**Royal Free Hospital Pears Building
Pond Street
London
NW3 2QG**

**Submission of Application for a MINOR MATERIAL AMENDMENT
to Planning Permission ref 2014/6845/P approved by the LPA on 25 April 2016**

Variation to Condition 23 to allow for alterations to the approved vertically hung and projecting louvered panels and the horizontal brise soleil at level 5 parapet height:

The Consented Position

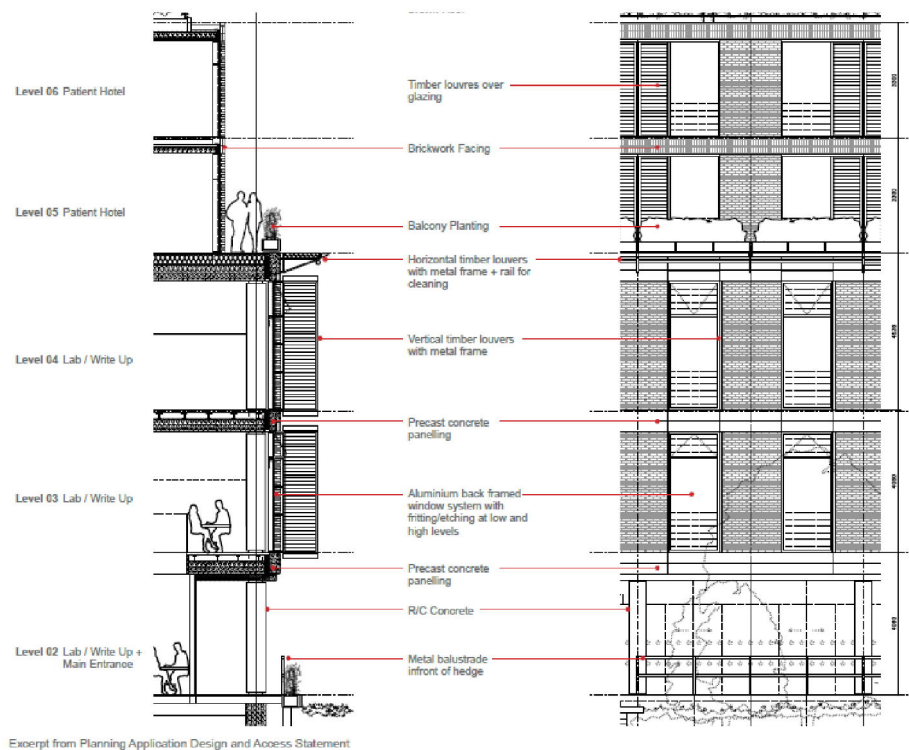
The surrounding frames within which the louvres were set were always proposed to be aluminium as shown on the originally approved plans, it was only the *individual louvres to be set within these frames that were proposed to be timber*. This timber material was shown on a number of CGI's and set out within the Design and Access Statement shown overleaf.

- I. Alternative use of aluminium individual louvres within vertically hung and projecting panels, in place of the approved timber louvres, to be set within the (as approved) aluminium metal framing.*
- II. Reduction in projection depth of the horizontal brise soleil at level 5 parapet height, and alternative use of aluminium individual louvres in place of the approved timber louvres*

III. Reduction in projection depth from 1000mm to 750mm of the projecting louvres
